Docket Items # 3 & 4  
BAR CASE # 2012-0005 & 0006

BAR Meeting  
February 1, 2012

**ISSUE:** Additions/Alterations  
**APPLICANT:** Thomas Byrne, Applicant  
**LOCATION:** 420 South Lee Street  
**ZONE:** RM/ Residential Townhouse Zone

Figure 4: Proposed Screen Porch Detail

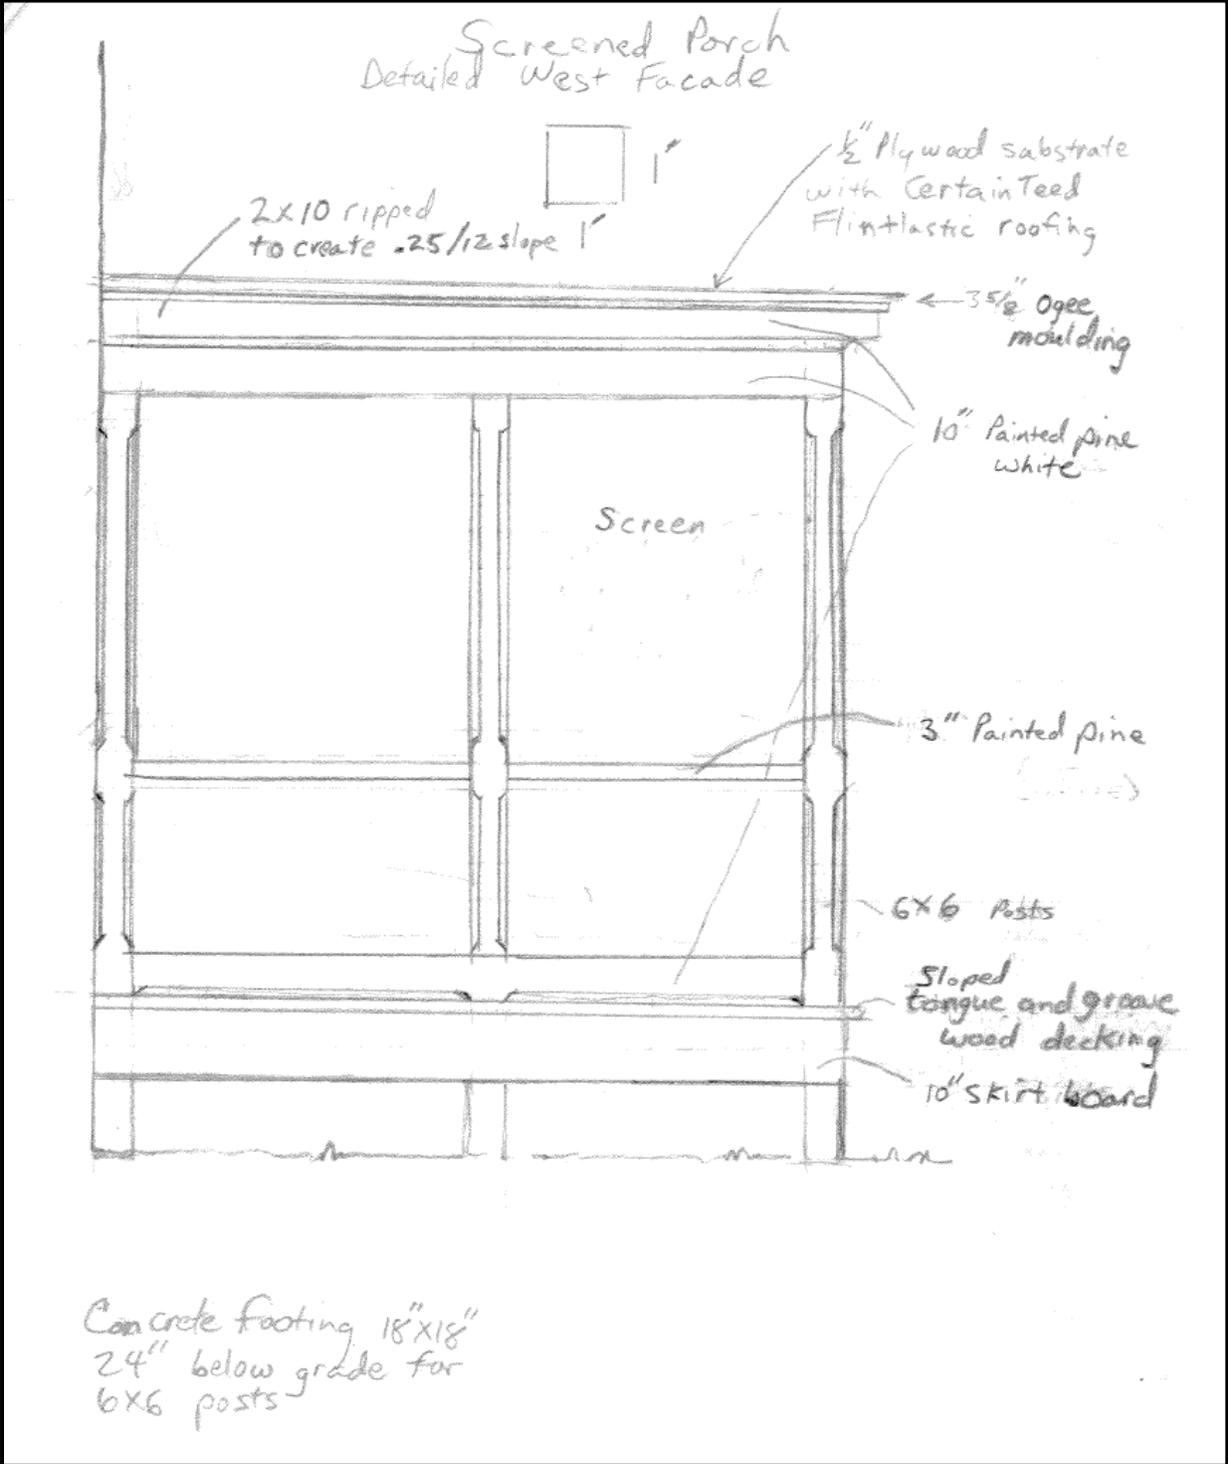
- C-4 The height of the porch above grade is not shown. If > 30" above finished grade porches must have guardrails on open sides. Guardrails and intermediate rails must comply with USBC.

- C-5 The drawings do not show steps or stairs. Stairs must comply with USBC. Stairways of 3 or more risers require handrails.
- C-6 Prior to the issuance of a demolition permit or land disturbance permit, a rodent abatement plan shall be submitted to Code Enforcement that will outline the steps that will be taken to prevent the spread of rodents from the construction site to the surrounding community and sewers.

**Figure 7: View of South elevation of house looking East with outline of proposed porch on extension**

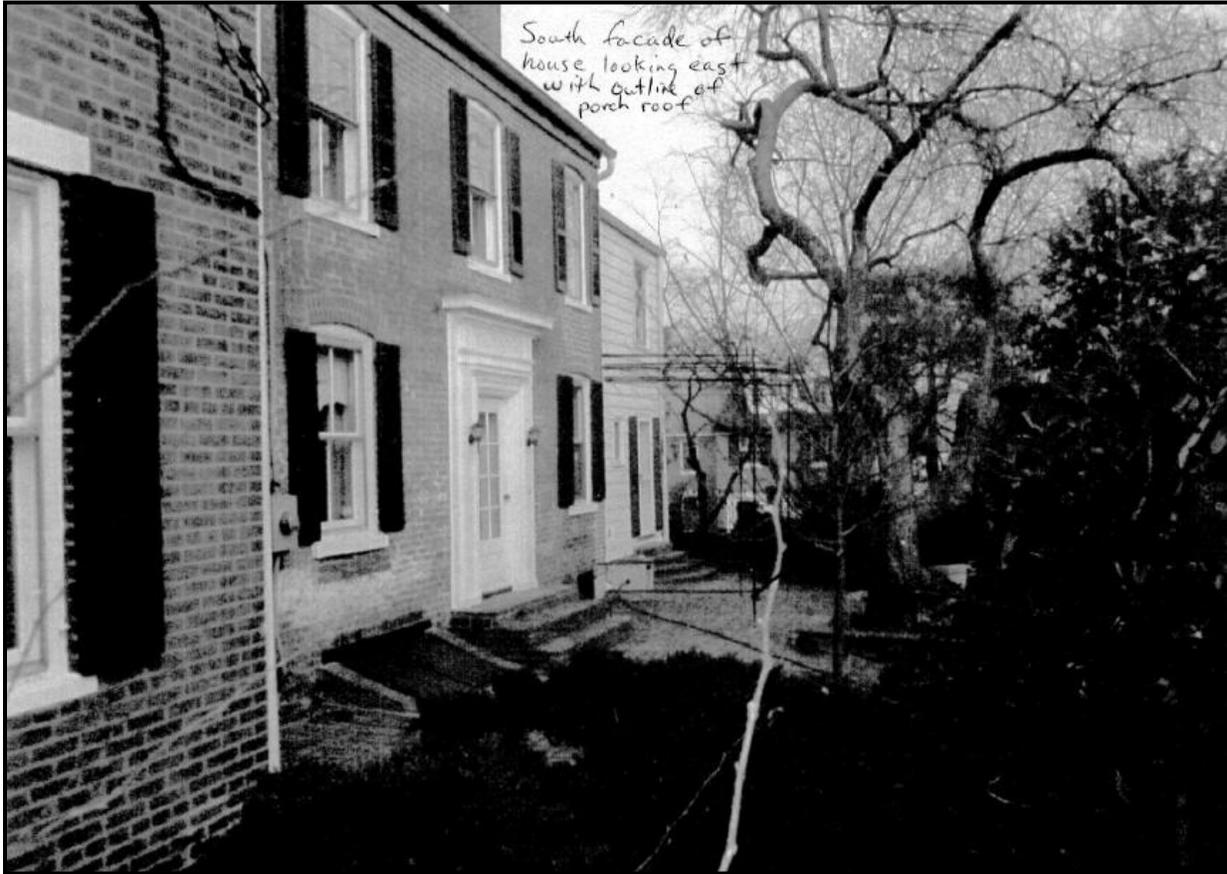
The *Design Guidelines* specify porches as "important architectural elements especially on residential structures. They can serve as a defining element of an architectural style." In keeping with the recommendations contained in the *Guidelines*, the screen porch is designed as a secondary feature "...allowing the historic structure to maintain the primary visual importance" and "echo the design elements of the existing structure." The proposed screen fabric will be mounted between new, chamfered columns and horizontal wood railings. This architectural detailing is simple in detail and design, while referencing the early 20<sup>th</sup> century period of the addition. Additionally, as the porch will be painted to complement the predominant color of the extension (white), it will blend in to the existing architectural details on the building and not negatively impact the resource as a whole. Finally, the applicant will build the porch so that it abuts the existing ell and is supported by treated wood footings, so that it can be easily unbolted in the future with minimal adverse impact on the house or potential archaeological resources. In the opinion of Staff, the design of the screen porch addition is compatible in style and massing to the existing historic house, and conforms to the *Design Guidelines*.

**Figure 12: Interior View of Original Location of Entry Door on Frame Extension  
(Proposed Location of New, 2/2 Double Hung Window)**

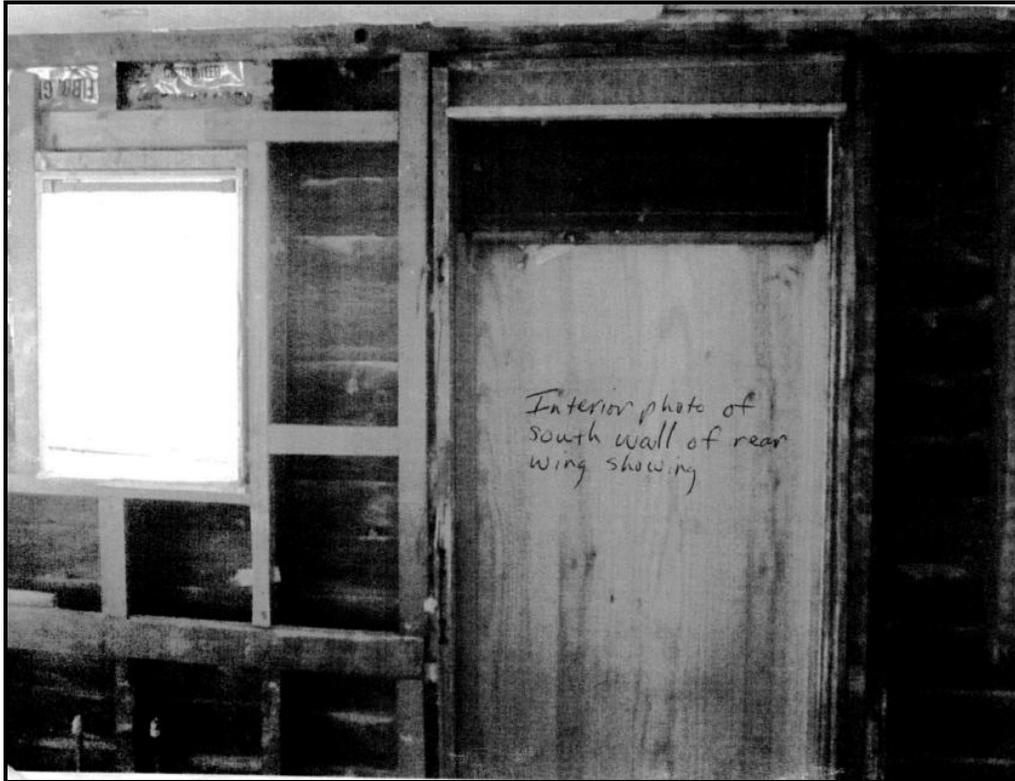
The fenestration on the two-story frame extension has been modified over the years. Based on visual evidence, the first floor entry door has relocated from the west to the eastern portion of the wall and a small casement window has been added. Additionally, a stained glass window was installed on the rear elevation by the previous owner. Staff does not object to the proposed installation of the new, double hung, SDL, 2/2 window in the previous entry door's frame (see photo on page 15) and the installation of a new box bay window with standing seam-metal roof. However, based on the age of the addition (c1900), Staff cannot support using the proposed aluminum-clad wood windows. The Board's *Window Policy* states that aluminum-clad wood windows are to be utilized on buildings which were constructed after 1969. Therefore, staff recommends that the Board approve the application with the condition that the applicant install painted wood, 2/2 SDL windows with a 1-1/8" muntin in accordance with the *Window Policy*.
